LINE	QUANTITY	UOP	CAT NO	ITEM NUMBER	UNIT PRICE	AMOUNT
ADDENDUM NO. 04						
ADDENDUM ISSUED TO PUBLISH AND DISTRIBUTE THE FOLLOWING INFORMATION TO THE VENDOR COMMUNITY AS ATTACHED.						
0001	1	LS		968-20		
NEW STATE OFFICE BUILDING IN CLARKSBURG, WV						
***** THIS IS THE END OF RFQ GSD136433 ***** TOTAL:

Addendum Number: No. 04

Addendum issued for the following informational changes and updates.

Clarksburg State Office Building
GSD 136433

PROJECT NO.: 0610123.05
DATE: NOVEMBER 19, 2013
SHEET NO.: **A501**

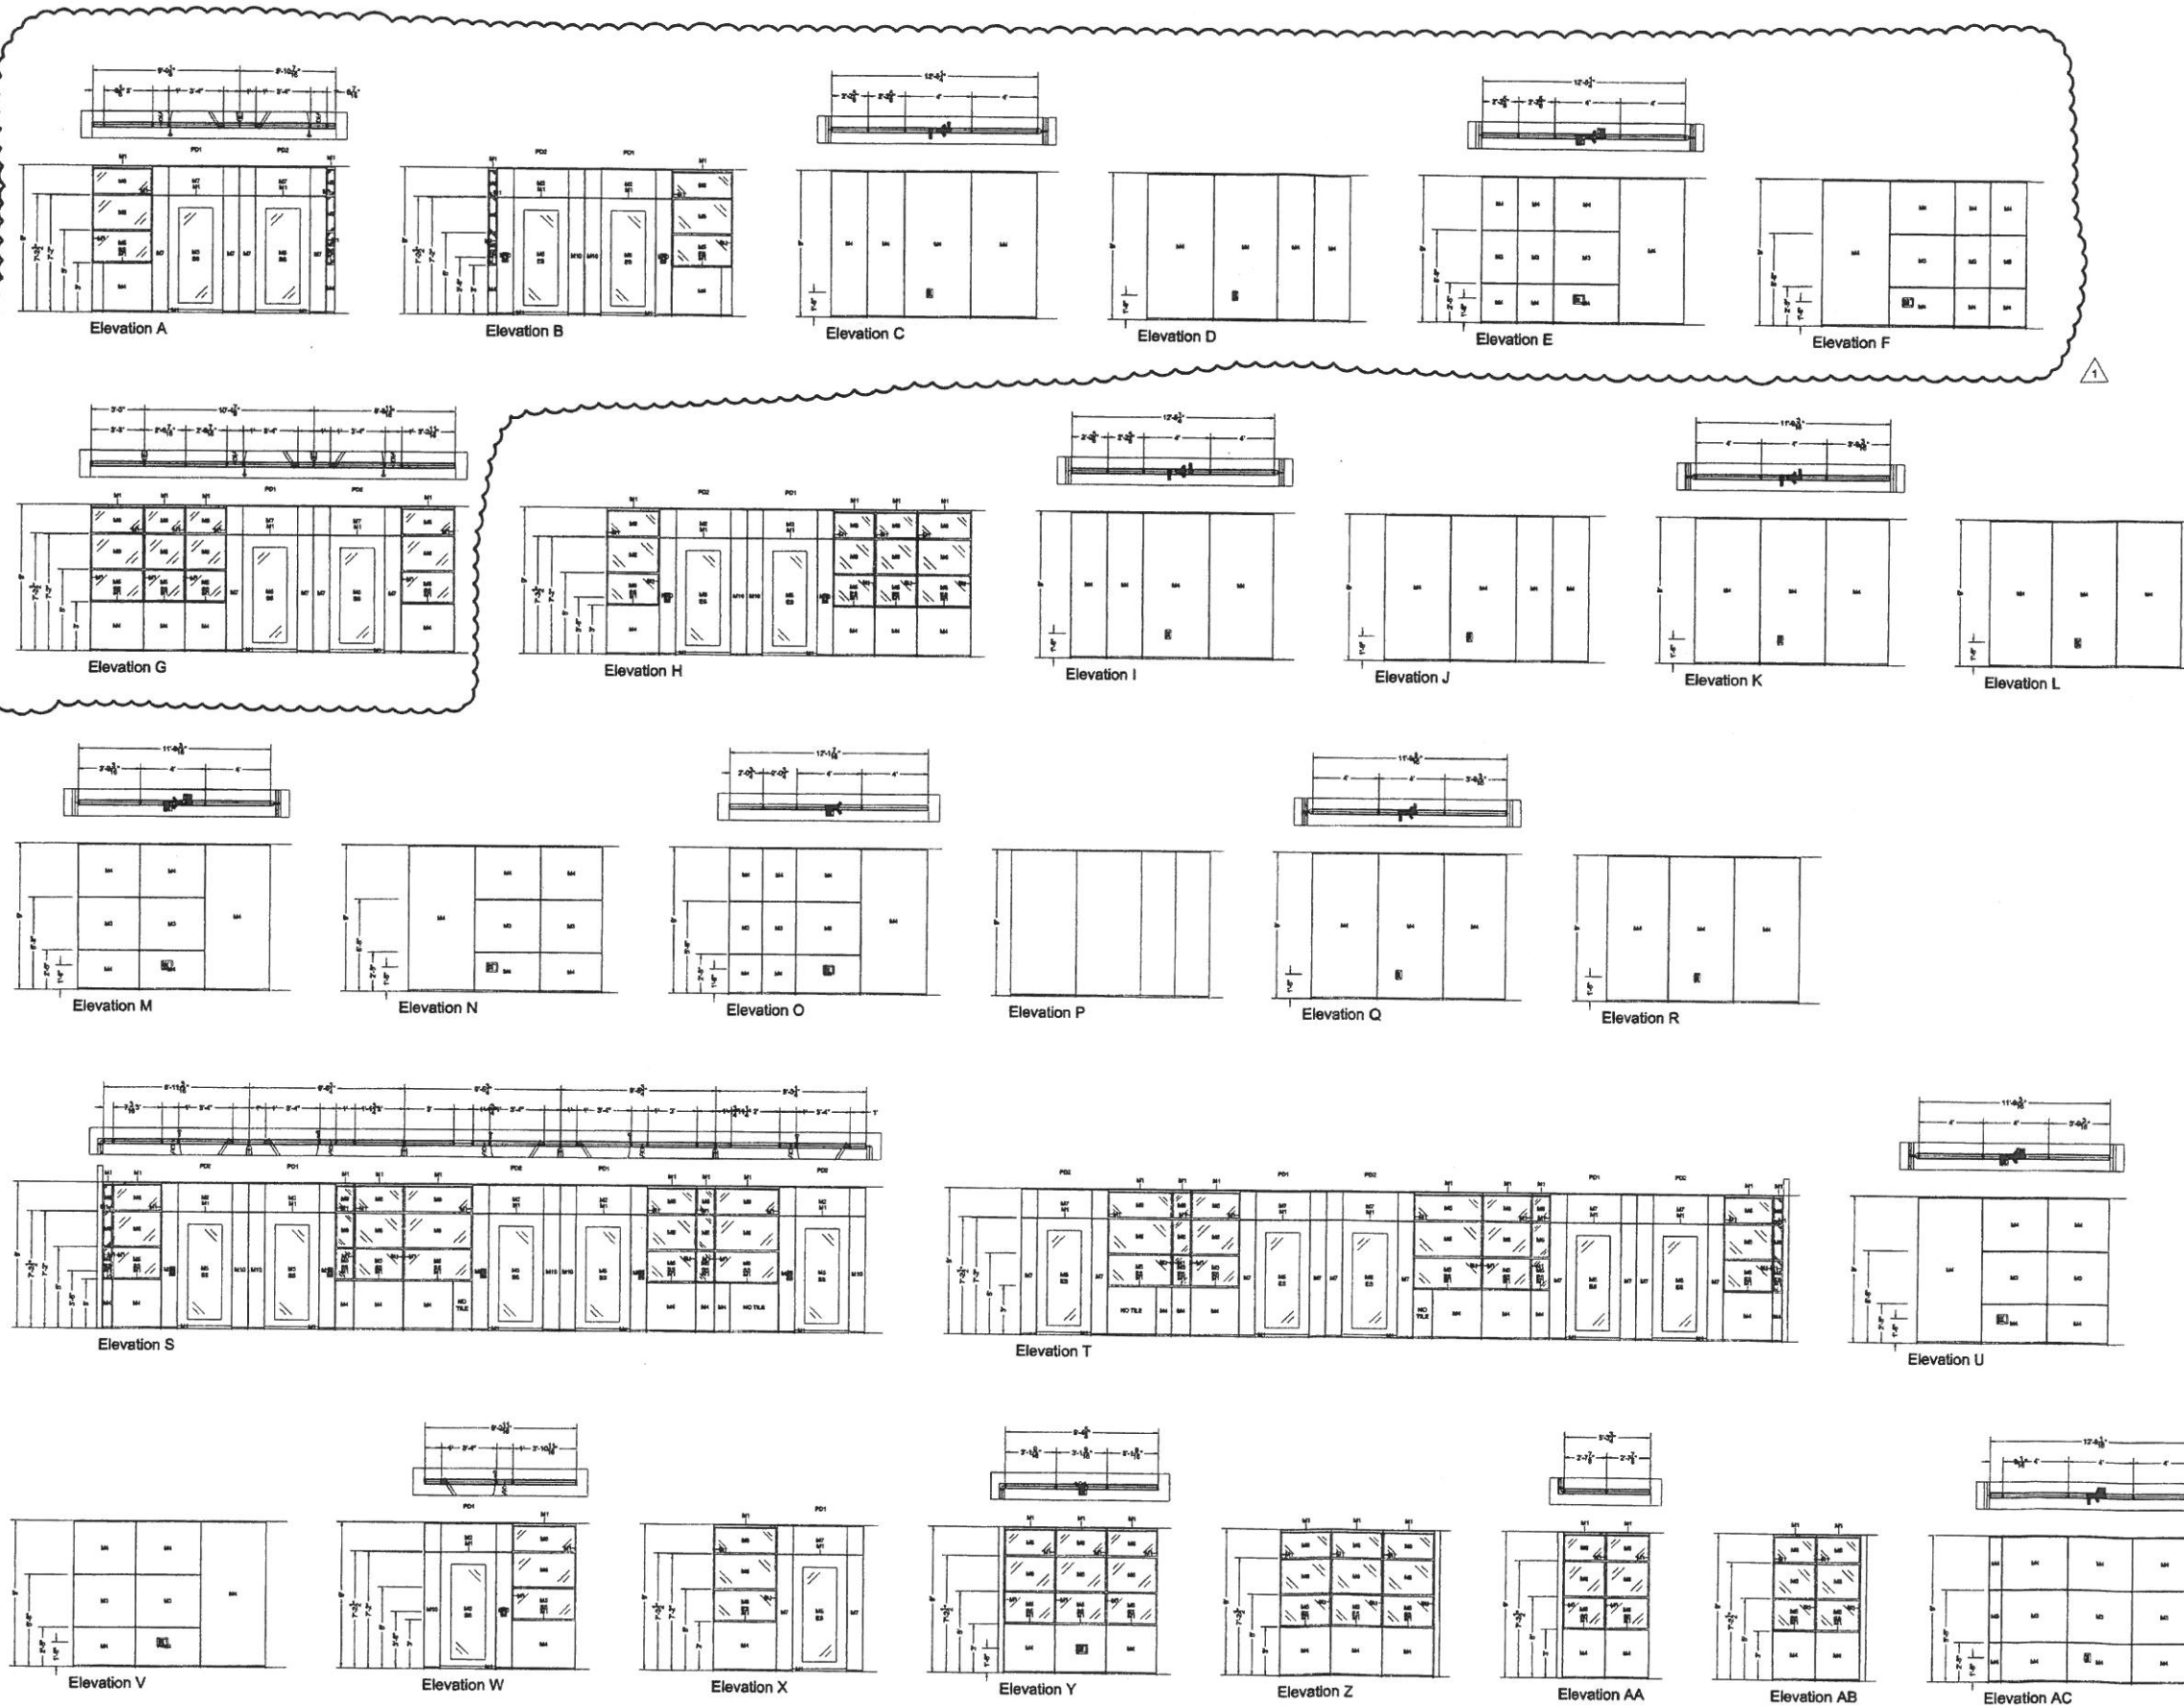
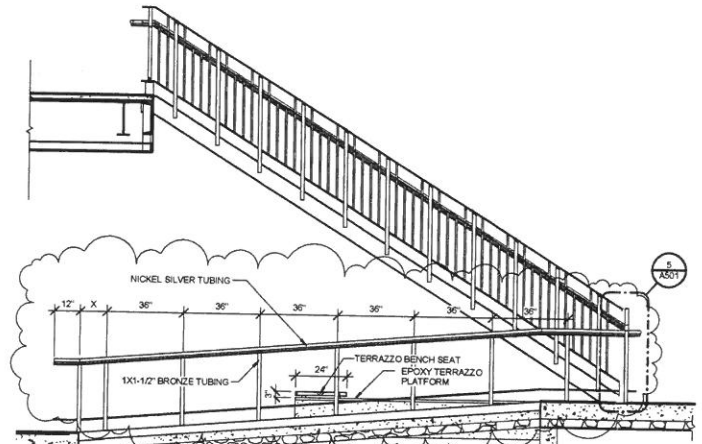
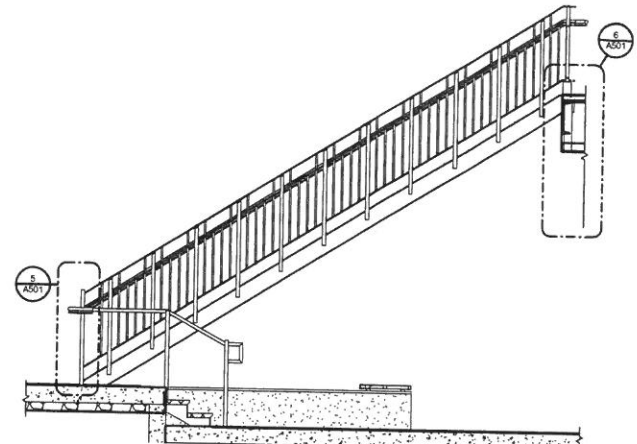
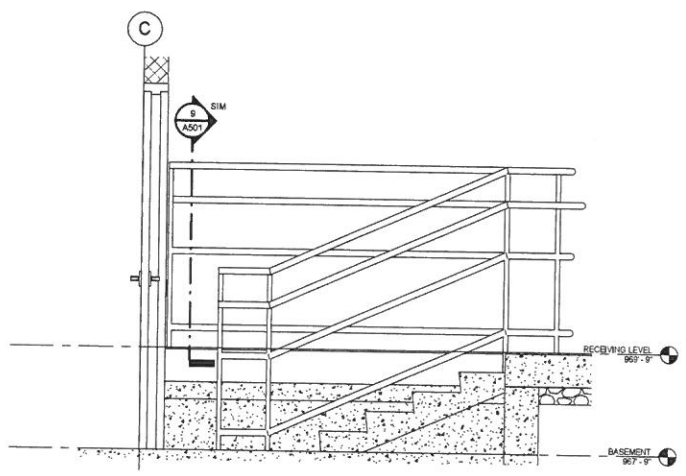
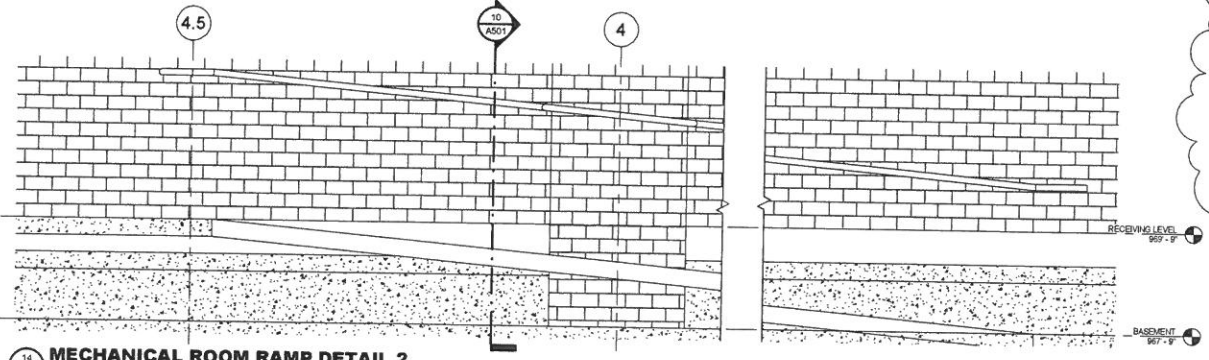
- 3.04** Sheet A402 Elevation 6/A402
REVISED: Step Flashing at Canopy
See AD004 4 of 7 Appended to this Addenda.
- 3.05** Sheet A501
OMIT: Sheet A501 as found in Issued for Bidding Documents
ADD: Sheet A501 as appended to this Addenda.

115. Regarding Employee Stair: Detail 7/A501 calls out 1 x 1 5/8 tubing beyond. A.) it does not say what kind of material. Please clarify. B.) This is not a valid size for either bronze or steel, please clarify.

118. Detail 7/A501 – 1 ¼ x ½ bronze channel nickel silver tubing, please clarify what this is.

119. Detail 4/A501 – ramp rail at bottom of stair, what holds up the rail at this point?

A.115. Bronze tubing as post to be 1 x 1-1/2. See corrected drawing A 501 in this addenda.

A.118. Omit nickel silver tubing from note, see new drawing A 501. Nickel silver tubing refers only to 1-1/2" dia. Handrail.

A.119. See corrected drawing A 501 in this addenda.

A611

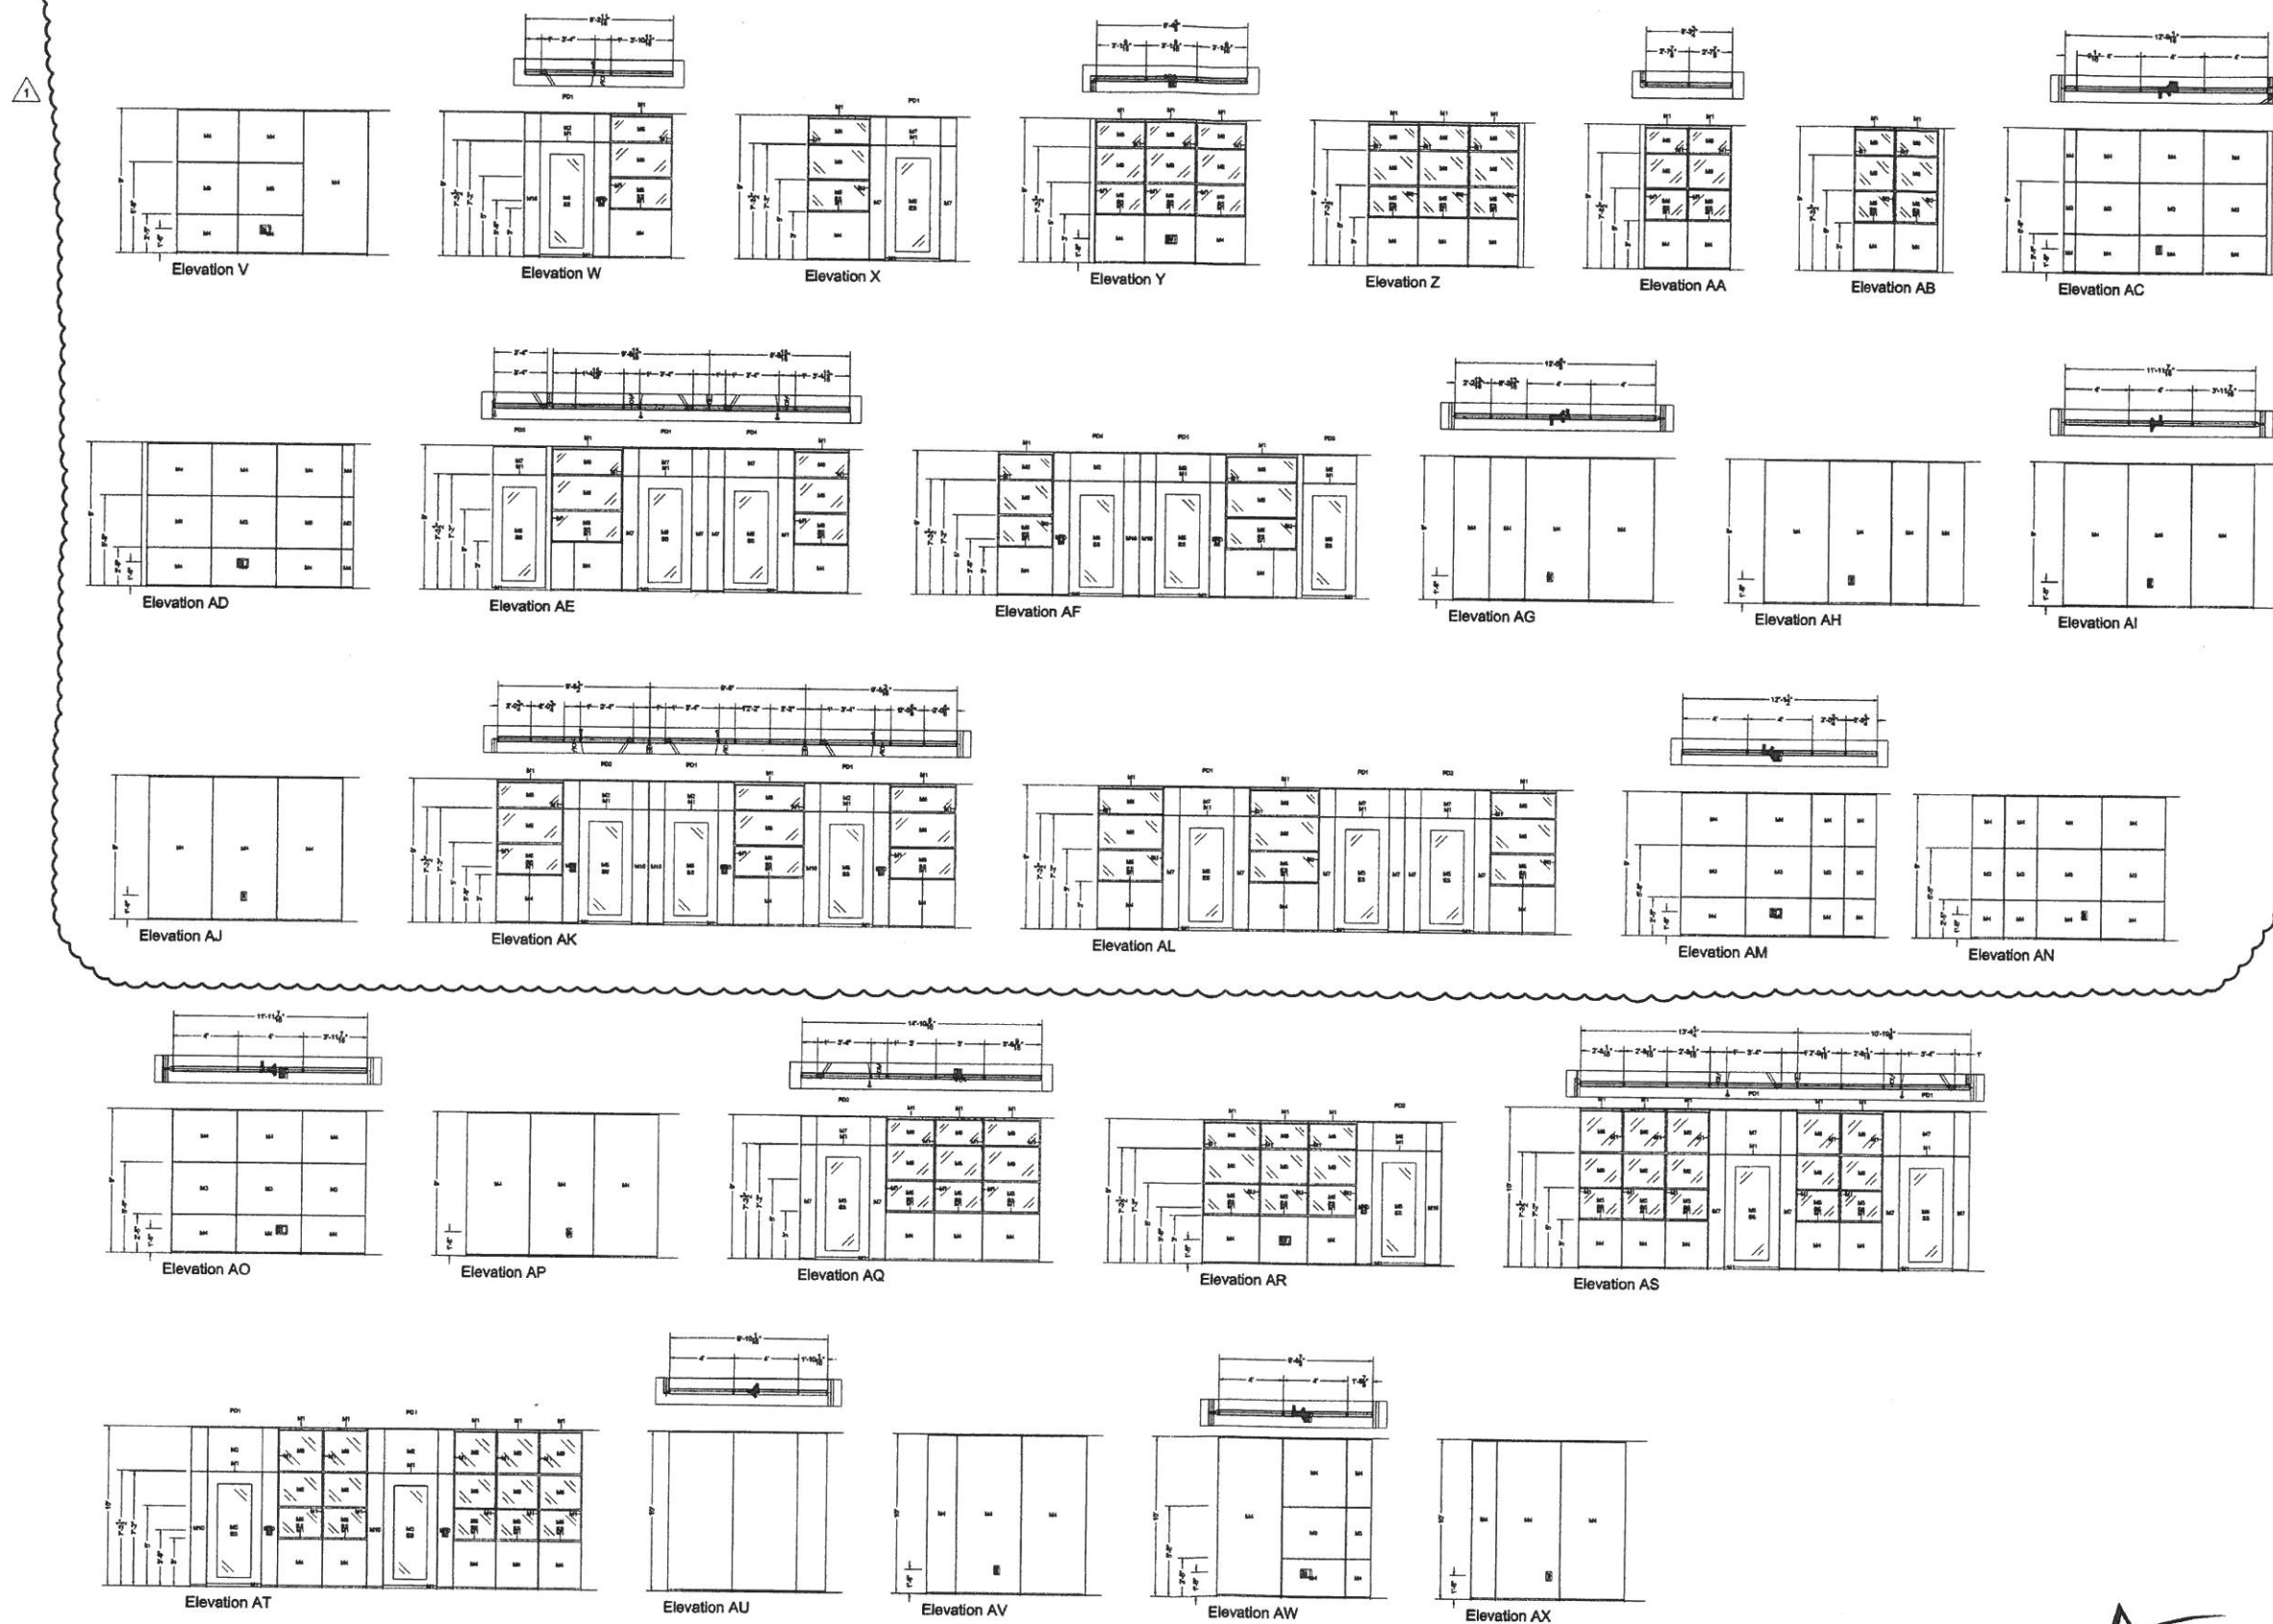
- 3.12** Sheet A611, A612, A615
OMIT: A611, A612, A615 as found in the Issued for Bid set.
ADD: A611, A612, A615 as appended to this document.

86. On drawing A609, there are elevations A thru F indicated on the plan however there are no corresponding elevations on drawing A611, please provide.

A.86 See this Addendum for revised A611 drawing.
